### **Stations Design Update**

# GREEN LINE EXTENSION PROJECT DECEMBER 4, 2018 COMMUNTY WORKING GROUP MEETING – SUMMARY MINUTES

LOCATION OF MEETING: GLX Project Office, 200 Inner Belt Rd, 3<sup>rd</sup> Floor, Somerville, MA 02143 DATE/TIME OF MEETING: December 4, 2018; 4:00 PM – 6:00 PM

### Street Level - North Headhouse and MBTA Bus Loop

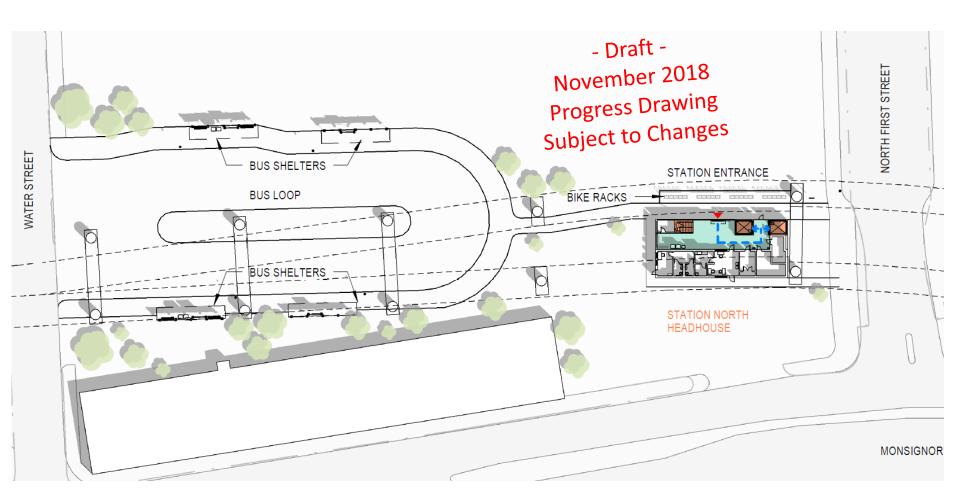
Asked for clarification on presentation side 4, GLXC stated that Boston and Science Park Station would be off to the left of the drawing and that what was shown was the north headhouse of the station.

Responding to a question about how pedestrians would enter the station, GLXC said there is a south headhouse on East Street and a north headhouse on North First Street.

It was asked which headhouse was the primary entrance for Cambridge Crossing. GLXC said that the busway would be nearer to the north headhouse and would probably be the entrance that would be used.

It was asked how the buses coming from Somerville would go to get to the bus loop. The GLX team said it would turn on Water Street.

It was asked if bus transfers at the Station would be changed. The GLX team said that there are 4 different berths for buses on the bus loop for the 4 buses that currently service Lechmere, but future plans have yet to be determined.

A member asked about the north headhouse entrance and if people coming from the highway side would have to walk around the station to enter (see slide 9). The GLX team confirmed this will be the case.

# **Union Square Station**

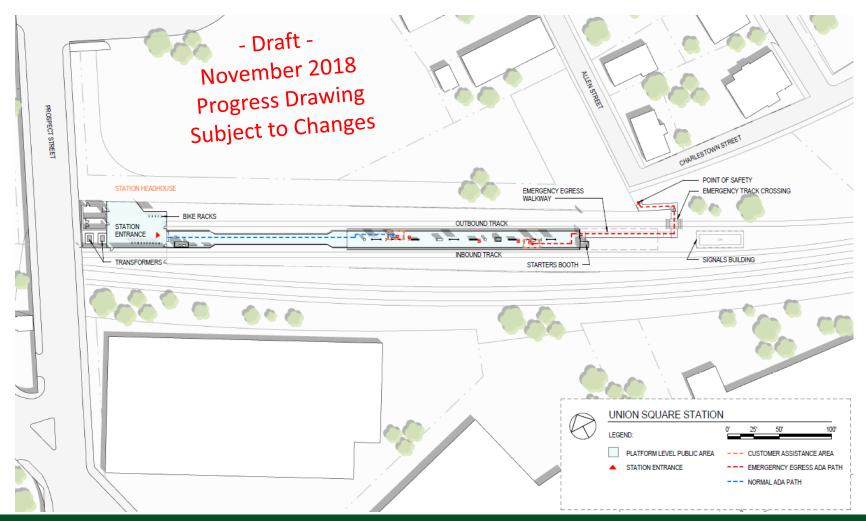
A member noted that except for Lechmere, all the stations are 3 car platforms. It was asked what the longer skinny portion of the platform level (on left side of drawing) was for. The GLX team said it allows for 2 cars to be stored past the platform for staging at the beginning of the service day or for storage of a disabled train.

It was asked if the station entrance on the left of the drawing was going up to the bridge on Prospect Street. The GLX team said this is currently under discussion and the Union Square developer US2 has some preliminary designs ideas.

A member noted that some of the station area and components are being designed by the private developer US2. There is a lot of public discussion about the designs including interest raised about better pedestrian access from the Boyton Yards and the south side. One problem is the bridge, as constructed, is too steep and does not meet ADA and to fix would be cost prohibitive.

## **East Somerville Station**

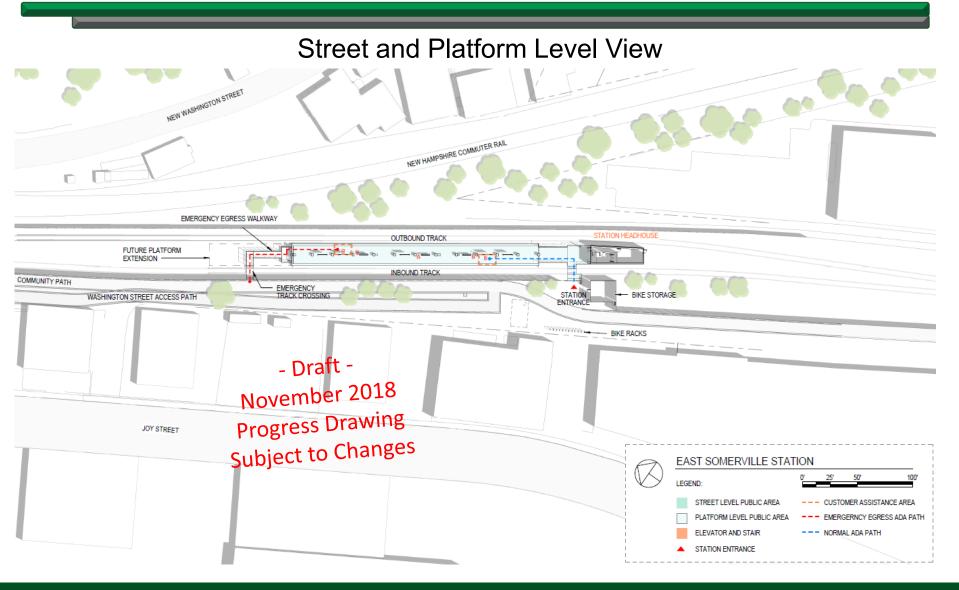
It was asked if this station was behind Cataldo Ambulance. The GLX Team clarified that Cataldo was on Washington Street which is just to the left of the drawing.

There was a question as to why the station entrance wasn't on Washington Street (left side of drawing) and was so far from the street. The GLX team said that the access path show on the drawing needs to ramp up to station.

It was asked if stairs could be at Washington side in addition to ramp. The GLX team said that this would not comply with the equal access policy for ADA compliant access.

It was asked if the access path would be a maintained sidewalk and if it was different from the Community Path or if they merge. The GLX team said the two paths merge at the station

A comment focused on where the access path merges with the Community Path. Concern was noted about bicycles flying by.

It was noted that an earlier design had an elevator and entrance at Washington Street. The GLX team said that the earlier design was very complicated and cost prohibitive.

It was asked if there would be access from Joy Street and would there be a fence. GLXC confirmed there would be no access from Joy Street and the area would be fenced off.

It was asked what was meant by the future platform extension in the drawing. The GLX team explained the platform was currently designed for 3 car trains but the design does not preclude a 4-car train in the future.

# **Magoun Square Station**

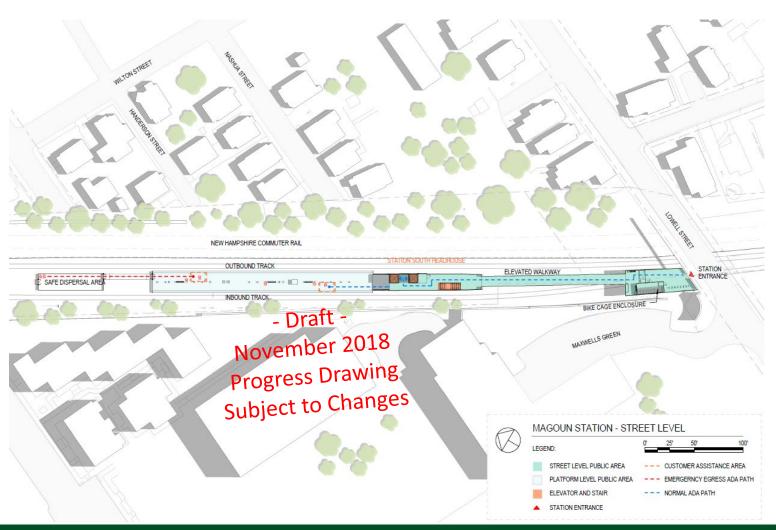
It was asked what the elevated walkway is that is shown in the drawing on slide 18. The GLX team explained that one would enter the station from the Lowell Street Bridge and travel down the walkway to where they would access stairs and/or elevator to get to platform. The walkway provides the distance necessary to get the trains under the bridge and to meet the platform.

It was commented that the Community Path looked like it was a variable width at this station. The GLX team explained that the Community Path was not at this station; the GLX portion stops at Lowell Street and does not connect to the station.

# **Ball Square Square Station**

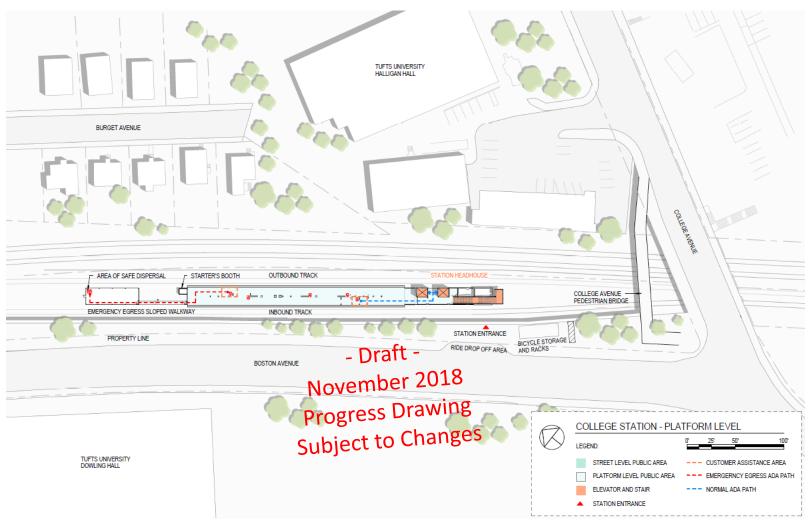
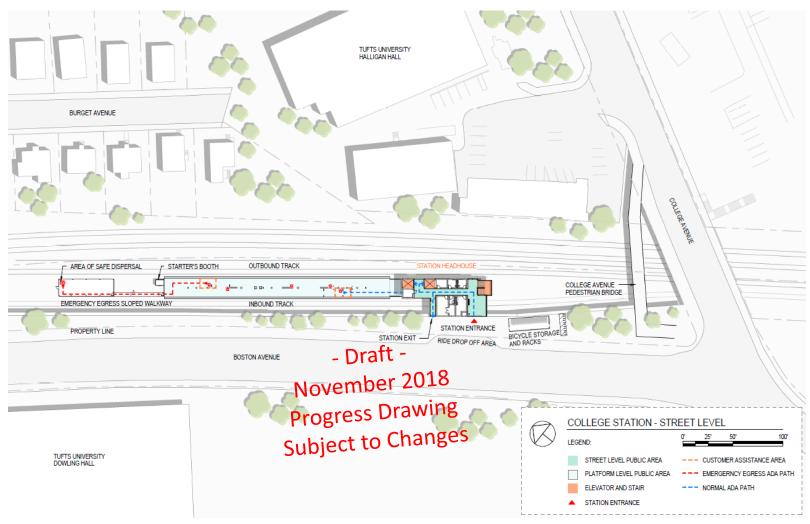
It was asked if there was only one elevator at the station because of the egress on the street level. The team confirmed this.

It was asked if at the Boston Avenue station access entrance users would be crossing the tracks at track level. The team confirmed this to be the case.

Asked about the future TOD labeled on the drawing (slide 19), the GLX team said the MBTA real estate and transit-oriented development (TOD) team would work to sell the property when GLX was complete.

Asked what the "Hrail Access Pad" labeled on the drawing was, the GLX team said this was for maintenance.

A question was raised about whether a future platform extension would interfere with the emergency access from the station to Boston Avenue next to the apartment buildings. The GLX team said a design for that scenario would have to be looked at.

It was clarified that the station access entrance from Boston Avenue would cross the tracks at grade and it would be right at where the train stops allowing for a safe pedestrian crossing.

It was inquired if the hatched box at the bottom right of the station on the drawing (slide 23) was landscaping. The team said it was a bicycle rack.
